## Product Change Notification

May, 2018

### Bourns® Model SRP4012 and SRP4020 Series Shielded Power Inductors Change to Core Channel Design

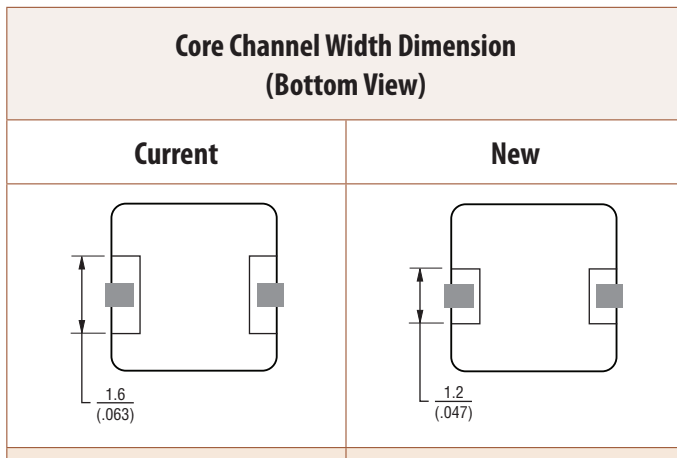
Bourns is changing the core channel design of the [Model SRP4012](#) and [SRP4020 Series](#) Shielded Power Inductors. The terminal positioning will change from 1.6 mm wide to 1.2 mm. Narrowing the core channel will better centrally align the terminal during manufacturing process.

The changes to the inductor core channel design will affect the inductor's form and its quality and reliability should be improved. The inductor's fit and function will remain unchanged. A list of the affected part numbers is shown in Table 1.
